Register Reference: SDZ22A/0011ai **Date:** 26-Aug-2022
Development: The proposed primary school will extend to c3,355sq.m will be 2 storeys in height and will comprise 16 no. classrooms with an additional 2 classroom Special Educational Needs Unit; a General Purpose Hall and all ancillary teacher and pupil amenities and facilities. The proposed development also provides for hard and soft play areas, including 2 no. outdoor ball courts, bicycle parking, staff car parking, vehicle drop off and set down areas. Photovoltaic Panels (PV) are proposed on roofs in addition to EV Charging Points and a packaged Biomass heating plant. The proposed development also provides for all Landscaping and boundary treatments and all associated site development works. Access to the site will be via a new junction and access road off Thomas Omer Way. The new access road will run south off Thomas Omer Way and then west into the site. The proposed access road is in accordance with the Clonburris Strategic Development Zone (SDZ) Planning Scheme and incorporates public lighting, footpaths and cycle tracks. A further pedestrian / cycle only connection to Thomas Omer Way is also proposed along the western gr

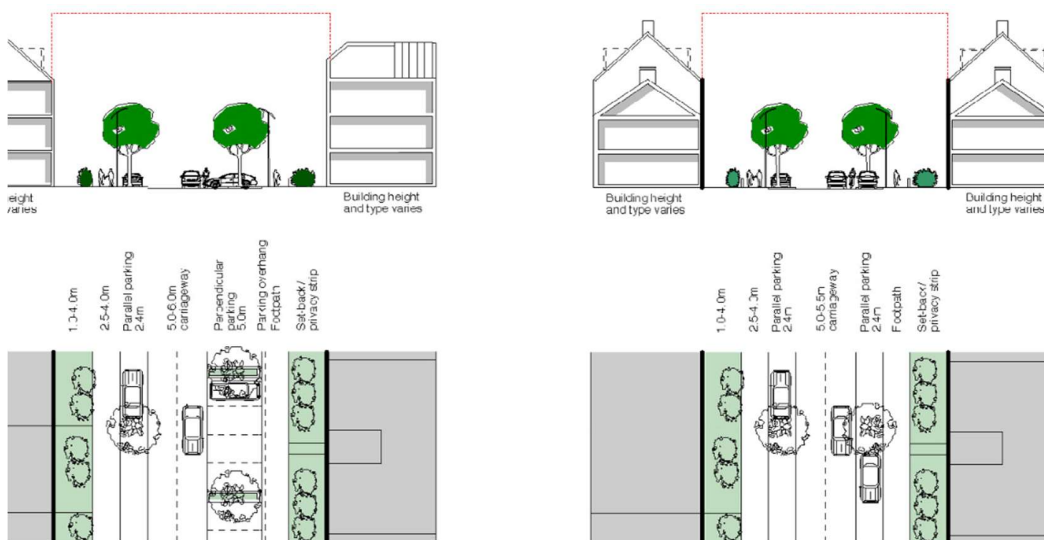
c. In terms of street design, it is not apparent that the proposed streets are laid out in accordance with the requirements of the scheme, the applicant is therefore requested to redesign streets to ensure compliance with Figure 2.2.6 of the Planning Scheme (and Figure 2.2.5, if relevant).

The carriage way of 6.7m width exceeds the allowable in planning scheme of 5.0m – 6.0m.

Applicant Response to FI Item 1(c) – *The revised access proposal to the proposed development from Thomas Omer Way is designed to be flexible in terms of its long term use and function in the context of the Planning Scheme. The proposed access road has been designed as a local street in accordance with Figure 2.2.6 of the Scheme, is designed in accordance with DMURS, and has been refined in accordance with the Stage 1 RSA. It has an overall carriageway width of 6.7m (3.350m individual carriageway width) with 2.7m set down areas either side with 2.2m wide footpaths provided either side. The street also includes a vehicular turning circle.*

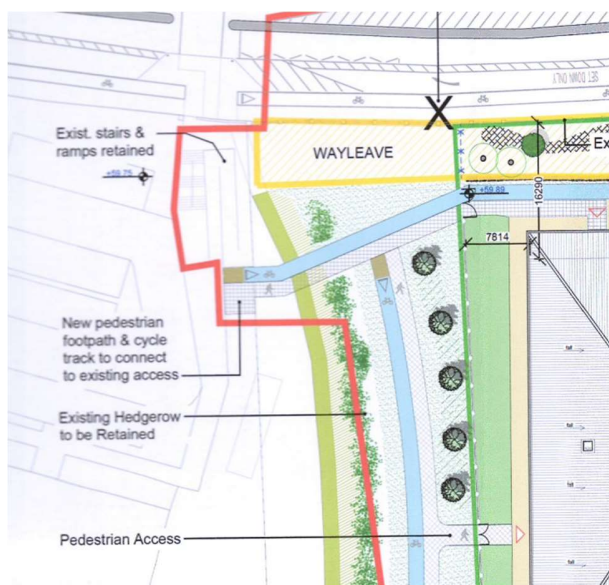
d. The Planning Authority is concerned that the applicant is providing pedestrian/cycle route to the west, adjacent to existing access points on the adjacent school site. The applicant is requested to assess whether it is possible to connect into these existing routes.

The entrance for pedestrians and bicycle to the west has been changed to form one access. The roads department are satisfied with the amendment.

Applicant Response to FI Item 1(d) - In direct response to the Planning Authority's request the proposed pedestrian / cycle route providing access to the site has been omitted and it is now proposed to utilise the existing, established access serving Kishoge Community College / Griffeen CC, adjacent to the site. At the request of the Planning Authority the application site area has been expanded as part of the Further Information response to include the existing steps and ramp. DDLETB on whose land the steps and ramp is located has provided a letter of consent to include this area in the revised application site. A copy of the letter of consent dated 16/01/23 is provided under separate cover.

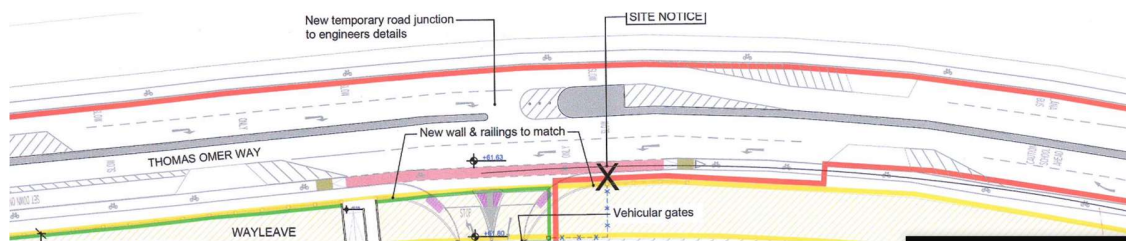
2. The applicant is requested to submit a revised layout of not less than 1:200 scale, showing how east bound vehicles will turn right from the Thomas Omar Road into the proposed link street (if retained).

The NTA and TII have made no recommendations in their report to the alterations to the bus lanes, therefore SDCC roads department are satisfied with the response.

Applicant Response to FI Item 3(2) - Vehicular access to the proposed development from the link street has been omitted and direct access from Thomas Omer Way is now provided. Please refer to enclosed Drawing Ref. SDP-AFEC-05-00-DR-A-1002

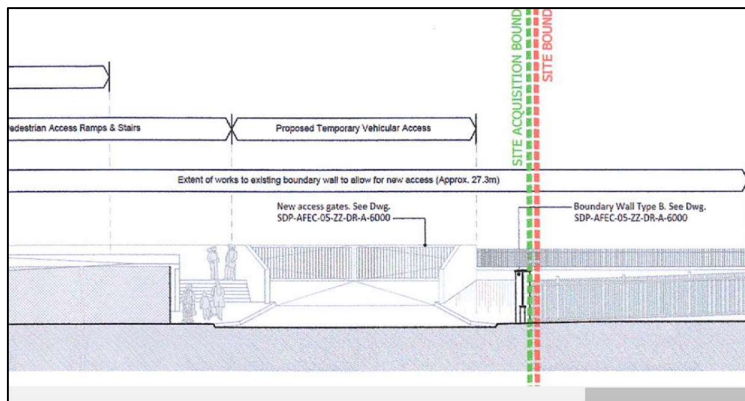
5. The applicant is requested to submit a revised layout showing the location of refuse collection points.

The applicant has submitted a refuse Autotrack.

Applicant Response to FI Item 3(5) - Please refer to enclosed Drawing Ref. *SDP-AFEC-05-00-DR-A-1002*
